EXHIBIT LIST FOR SUB 2019-002/EA 2019-008
Preliminary Plat of Cottonwood Creek # 3

STAFF REPORT TO THE BENTON COUNTY PLANNING COMMISSION

FILE NO: SUB 2019-002 (Preliminary Plat- 41 Residential Lots)
MEMO DATE: June 28, 2019
HEARING DATE: July 9, 2019
APPLICANT: Jerritt Wiser, Badger Properties II, 22307 S Cottonwood Drive SE, Kennewick, WA 99338
OWNER: Badger Properties II, 22307 S Cottonwood Drive SE, Kennewick, WA 99338
LOCATION: The property is located directly south of the Badger Mountain RV Resort between Cottonwood Drive and Cottonwood Creek Blvd (Parcel # 1-1188-302-0000-001).
PROPERTY SIZE: Approximately 16.78 acres
AREA TO BE USED: Approximately 16.78 acres
LAND USE: Residential
COMP. PLAN: Rural Transition
ZONING: Rural Lands One Acre District (RL-1)
SUGGESTED STAFF RECOMMENDATION: Positive recommendation subject to nine (9) findings of fact and seven (7) conditions of approval.

**Benton County Fire Marshal's
Review of Proposed Planning Applications**

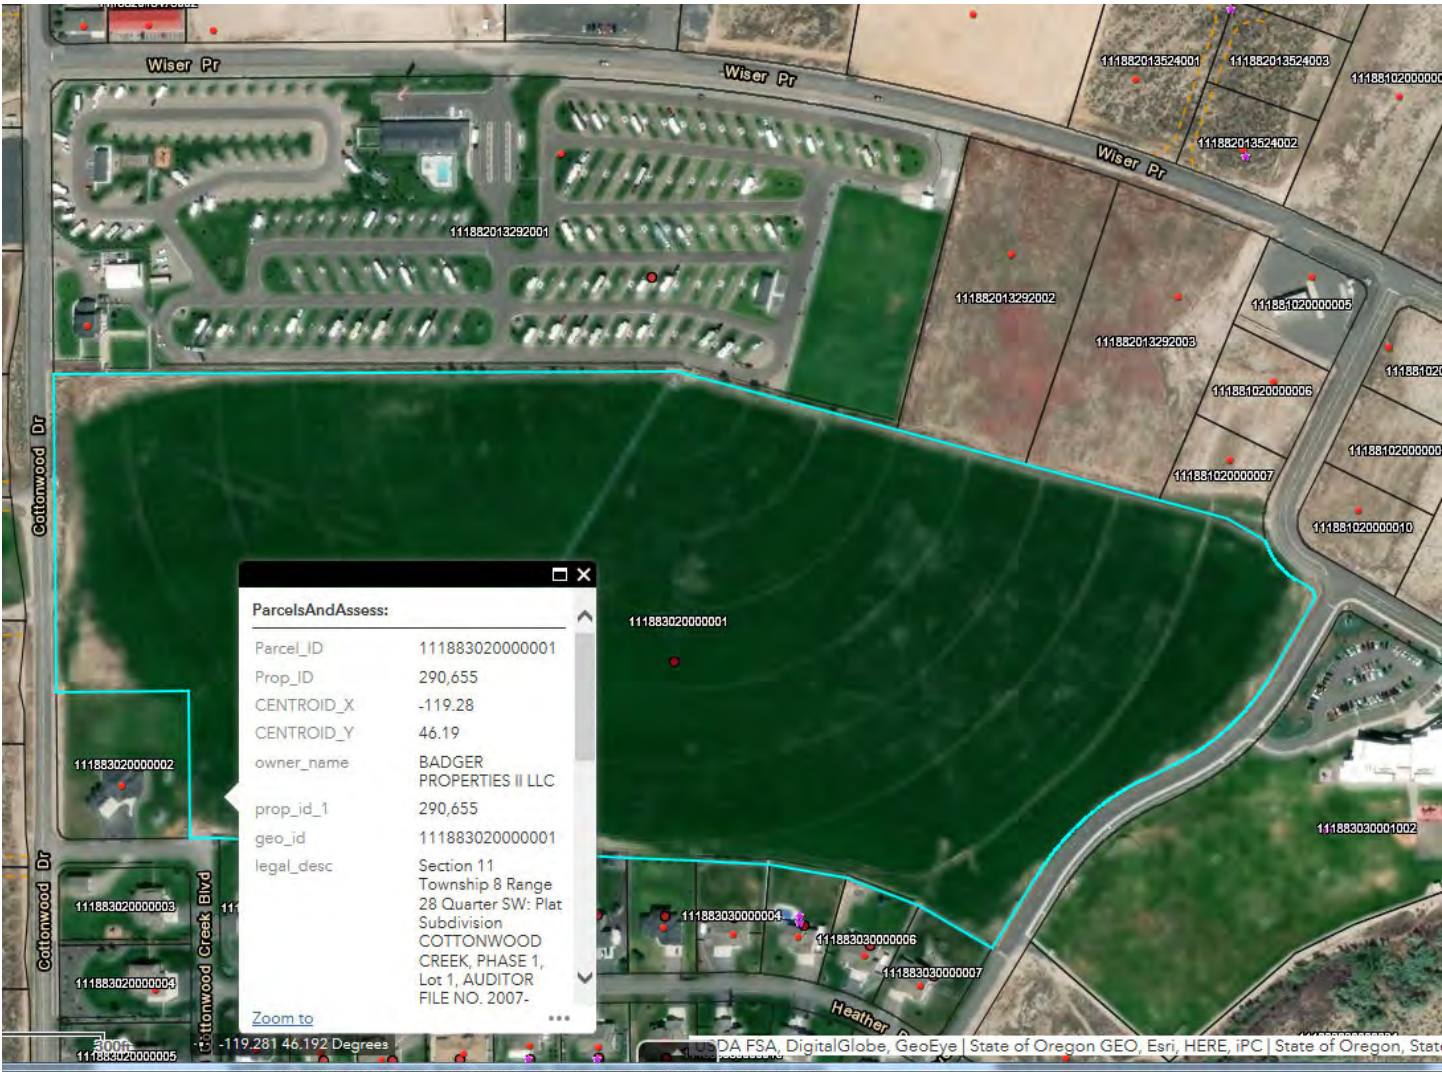
1. Hydrants are required, and their locations will be determined when utility drawings are sent for review.
2. Prior to preliminary plat approval, a letter from the water purveyor stating its willingness and ability to provide 500 gpm for 30 minutes at 40 psi static pressure and 20 psi residual, at normal peak instantaneous demands, is to be sent to the Benton County Fire Marshal.

3. Prior to final plat approval, a copy of the water system plans shall be stamped by a Wa. State registered Civil Engineer, and shall be signed by the water purveyor, shall, in PDF format, be given to the Benton County Fire Marshal, and DSHS.
